Associazione Italiana Aritmologia e Cardioritmo

Nota di chiarimento relativa all’avviso di sicurezza del 3 giugno 2019 inerente un sottogruppo di pacemaker della ditta Medtronic (Azure, Astra, Percepta, Serena, Solara)

June 26, 2019

Medtronic May 2019 Performance Note Summary

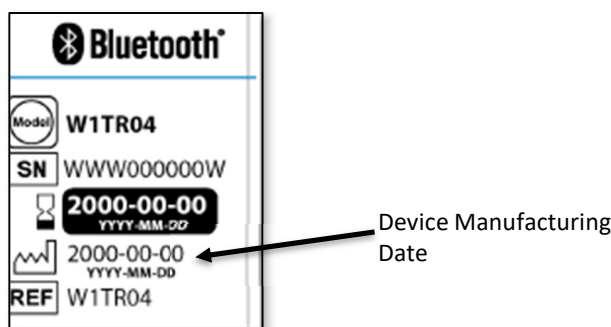
All product released into distribution (since their original market-release date) continue to perform within our reliability projections as established as part of the product development process. A series of enhancements to further reduce the potential for the capacitor to develop a leakage pathway was implemented beginning in February 2019. Given the low predicted rate of failure in the devices manufactured prior to these enhancements, we are not segregating existing inventory into “pre-”, “intra-” or “post-” enhancement categories.

Beginning June 1, 2019, all newly manufactured product released into distribution has been implemented with a new low voltage capacitor.

Important! Product with a manufacture date earlier than June 1, 2019 is considered safe to implant for the reasons noted above. No action on your part is required. This date is being provided per your request for information.
